Service Bulletin

Bulletin No.: 18-NA-246

Subject: Malfunction Indicator Lamp (MIL) Illuminated - DTC P0172, P06DE and/or P0521 Set (North America Vehicles Only)

Attention: This bulletin applies to the vehicles that have fuel enriched engine oil due to short driving intervals.

5207126

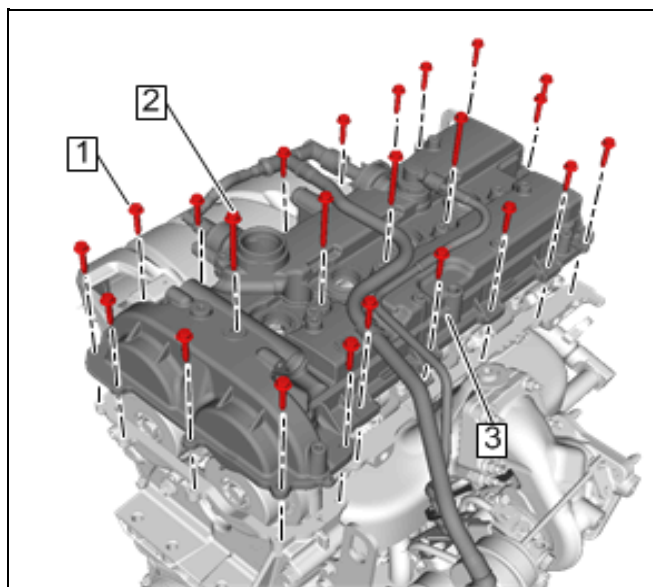
Note: The graphic above compares the old style primary PCV valve (A) to the new revised PCV valve (B).

1. Remove the camshaft cover (3). Refer to Camshaft Cover Replacement in SI.
2. Remove the old style PCV valve from the cover and discard.
3. Apply a light coating of oil to the new revised PCV valve O-ring.

4. Using hand pressure, install the new PCV valve into the cover until seated into bore.
5. Install the camshaft cover.
